**Section 75W Application to Modify Stage 1 Project Application MP09_0219
Shepherds Bay**

On Behalf of Holdmark Property Group

November 2013

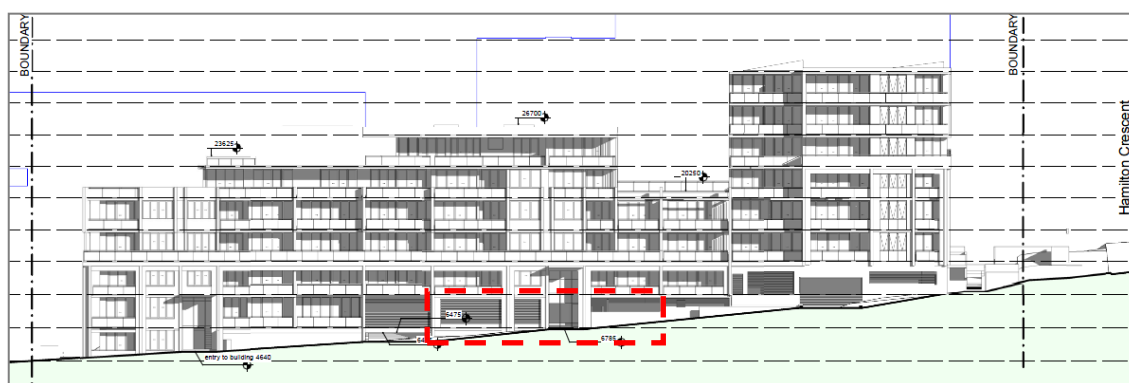
This issue affects the central portion of the eastern facade on the Upper Basement Level, and the central and rear portion of the western facade on the Upper Basement and Lower Ground

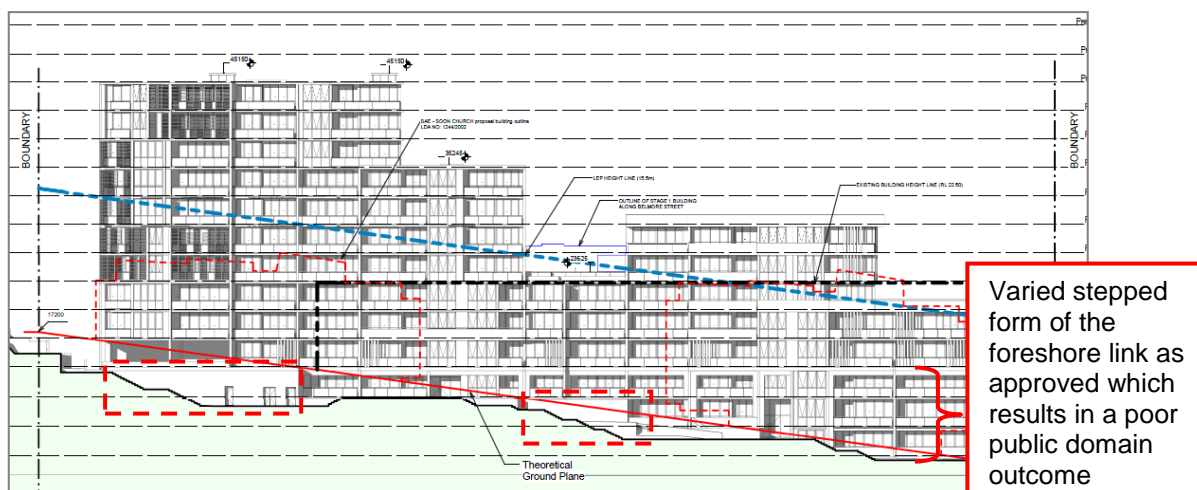
Floor Levels. The proposal also seeks to provide a more fluid slope for the foreshore link which adjoins the western facade of Stage 1. This is achieved through the introduction of concentrated 'scissor' stairway elements at the northern portion of the foreshore link and providing a more even grade for the remainder of the link. The revised through site link provides a better physical relationship to the existing sandstone platform, improves accessibility and now features pockets of level areas which simultaneously act as passive recreational spaces. The resulting improved relationship with the public domain is demonstrated in **Figures 8, 9 and 10** below.

Figure 11: Extract of the Upper Basement Level Floor Plans identifying the location of three additional units fronting Belmore Street (Units UB-11, UB-12 and UB-13) (Source: R+M)

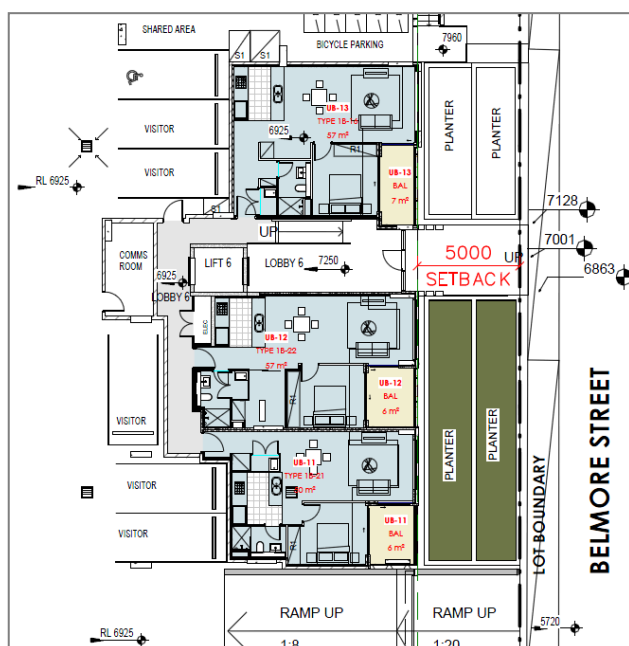
In relation to Belmore Street, the Architectural Drawings submitted in support of this application (**Appendix 1**) demonstrate the addition of three (3) x 1 bedroom units at street level (Units UB-11, UB-12 and UB-13). Also refer to **Figures 11 and 12** below.

Figure 12: Extract of the Proposed Belmore Street Elevation identifying the location of the three additional units (Units UB-11, UB-12 and UB-13) which activate the public domain (Source: R+M)

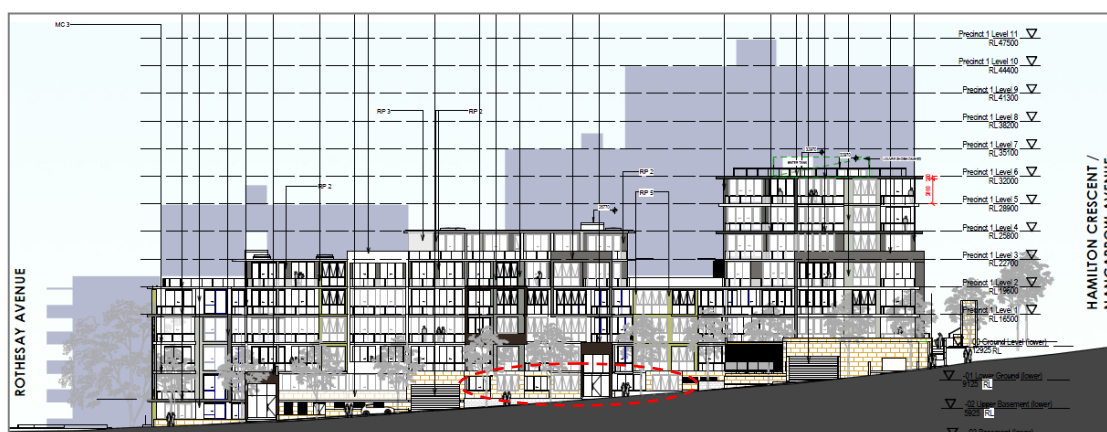
The provision of residential units at this level also improves the relationship with the street level through providing street activation and improved casual surveillance to the benefit of the local community.

Figure 13: Extract of the Proposed Upper Basement Level Floor Plan identifying the location of five additional units fronting the internal foreshore link (Units UB14, UB15, UB 16, UB17 and UB18 outlined in red) (Source: R+M)

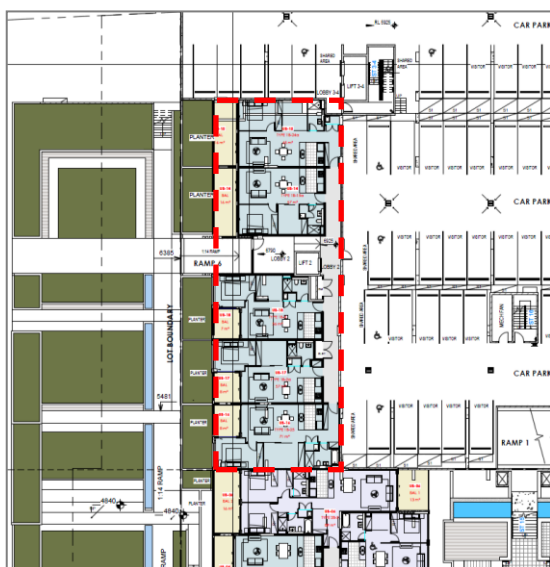
Integral to this, the proposal also seeks to improve the grades of the path of travel of the pedestrian through site link to the west of the Stage 1 building. In response, this proposal seeks to provide additional 1 bedroom units at the Upper Basement Level (Units UB14, UB15, UB 16, UB17 and UB18) and at the Lower Ground Level (Units LG24 and LG25). The locations of these additional units are identified in **Figures 13 and 14** below. The location of these units on the facade is demonstrated in **Figure 15** below.

The provision of residential units at these levels improve the sense of human scale when viewed from the through site link, in particular given the through site link now features level areas which simultaneously act as passive recreational spaces. This approach improves the ability to activate this publically accessible space and provide improved casual surveillance to the benefit of the local community. Most importantly, the design provides a visually interesting treatment which relates to the public domain and avoids blank wall treatments.

Figure 17: Extract of the Proposed Ground Floor demonstrating the provision of 2 residential units (GF-14 & GF-15 highlighted in yellow) in the former void area (Source: R+M).

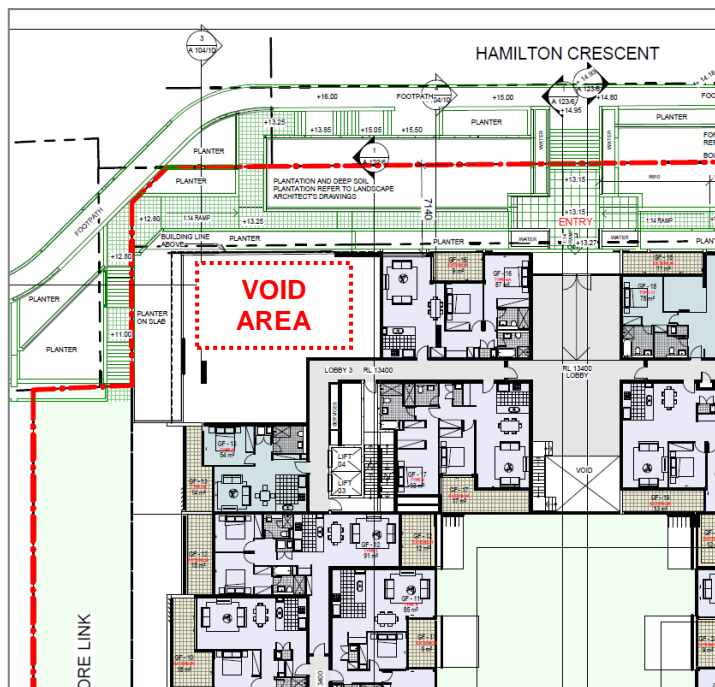
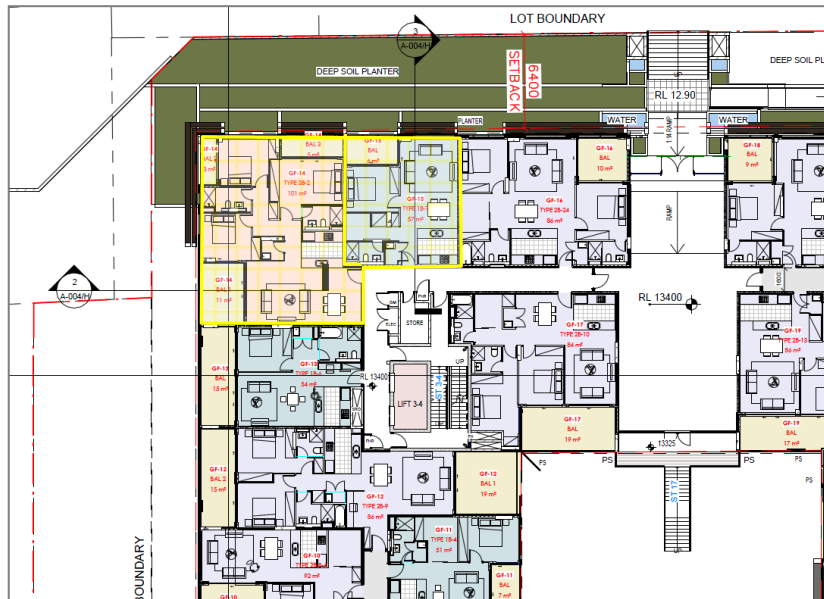
The final improvement to the development in relation to the public domain related to the Ground Floor Level, at the north-western corner of the site. As a result of the design modifications imposed by the Project Application (MP09_0219), this area has been approved as a void space. The proposal seeks to provide two (2) residential units in this space, as demonstrated in **Figures 16 and 17** below.

The provision of these two (2) residential units in this location is suitable given they reinforce the corner element of the building and provide a residential setting for the entirety of the northern facade. As demonstrated in the floor plan layout in **Figure 17** above, the placement of the window and balcony openings of these units are orientated towards private spaces, as opposed to the road incline of Hamilton Road to the north-west. The 3D modelling in **Figure 18** below, demonstrates the ideal relationship of these additional units in the context of the public domain.

Figure 19: Detail section taken through the centre of the balcony of Unit GF-14 demonstrating this unit is elevated above the level of the adjoining foreshore link and is capable of solar penetration to its balcony and living area (Source: R+M).

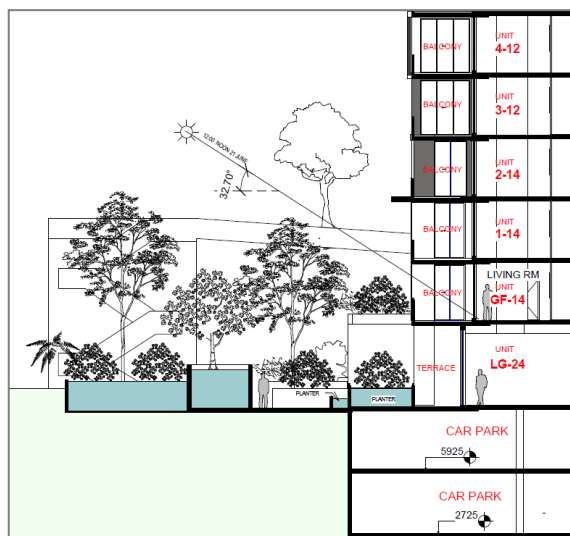
These units are afforded a high level of amenity given their separation to the public domain and screening measures and are considered to provide substantial improvements when considered in light of the overall development. Refer to **Figures 18 and 19** below which demonstrates these units also receive solar penetration to their balcony and living area spaces.

Figure 19: Extract of the Concept Landscape Plan demonstrating the landscape treatment to the northern street setback which provides sufficient deep soil planting to accommodate a mix of street trees, large canopy tree planting, buffer shrub planting and accessible paths of travel (Source: Place).

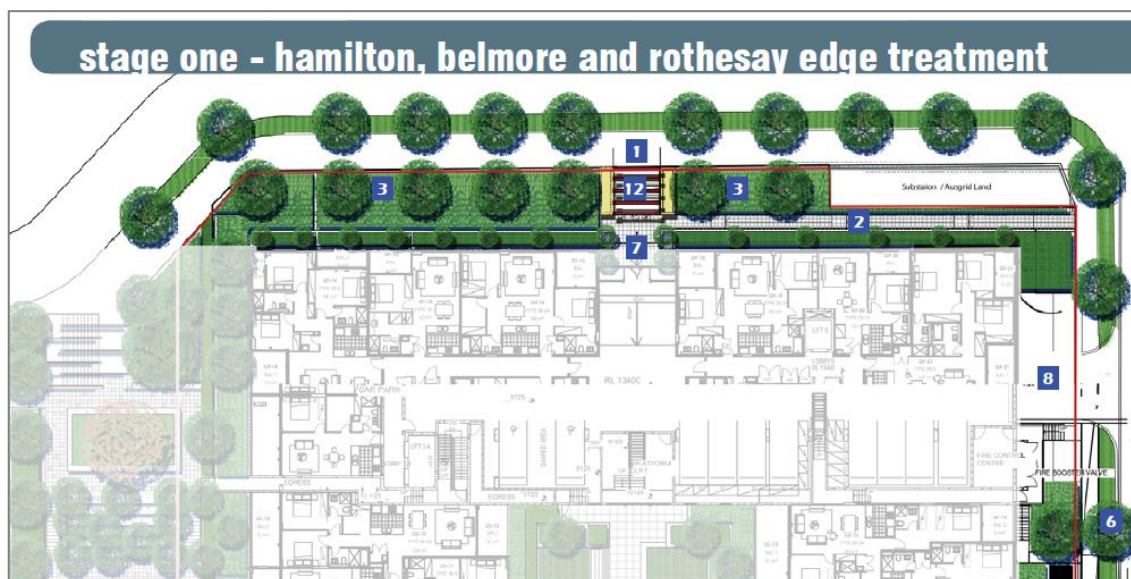
The reduced setback to the northern boundary to accommodate the basement levels does **not** compromise the ability for viable landscaping in the setback to Hamilton Crescent. The current conditions of the northern boundary setback comprise rocky materials and a lack of soil. This proposal seeks to excavate the rocks in this location, provide basement parking beneath with the provision of soil to act as a deep soil area with a soil depth of 2 metres which fosters viable and long-term conditions to support landscaping within the street setback area including large canopy tree planting.

As demonstrated in **Figure 19** below, the proposal maintains the extent and design quality of the landscaping within the private spaces as well as the public domain as demonstrated in the Landscape Concept Plans (**Appendix 5**).
